NESBIT SITE

Response to DMS Comments – MY2 (2023)

Nesbit Stream and Wetland Mitigation Site, Union County
Catawba River Basin, Cataloging Unit 03050103
DMS Project ID No. 100121, Full Delivery Contract No. 7868, RFP No. 16-007704
USACE Action ID No. SAW-2019-00832, DWR Project No. 2019-0862

DMS Comments Received (Black Text) & Responses (Blue Text)

Table 13A. UT-1 Channel Evidence

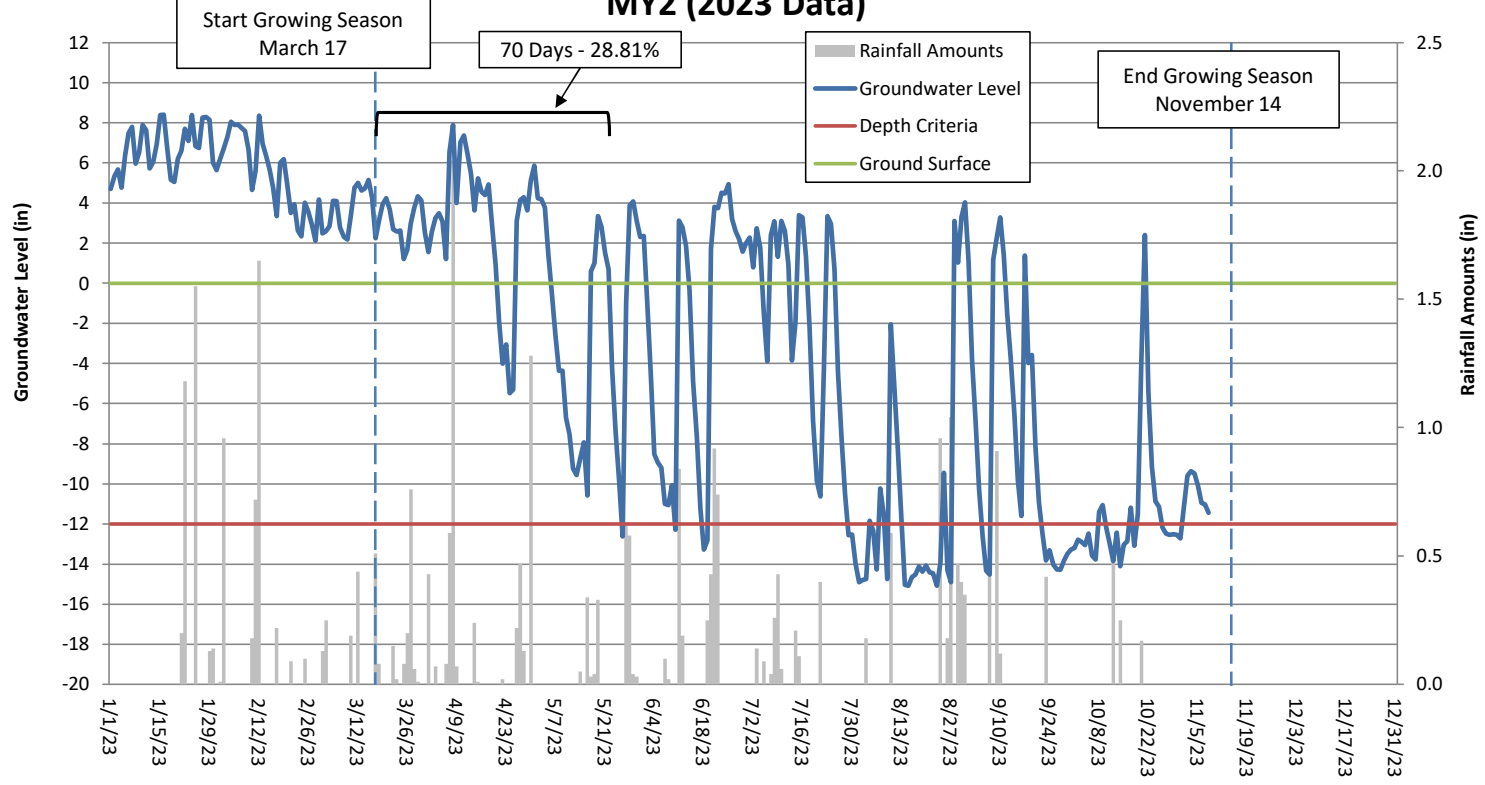
Response: Bankfull and thalweg elevations were added to the crest gauge graph. A legend was added to show each line type.
10. Appendix D. - Hydrologic Data - Nesbit Groundwater Gauge Charts 1-9: Add lines showing the ground surface and brackets showing the total number of consecutive days meeting the wetland criteria to the graphs. Add a legend showing each linetype/data point (precipitation, water level, depth criteria and ground surface).

Response: A ground surface elevation line, bracket for consecutive days meeting criteria, and legend were added to each groundwater gauge graph.
11. Appendix E, Table 14 - Project Timeline: Add all extra activities conducted at the site including supplemental boundary marking, soil amendment application and planting to the table.
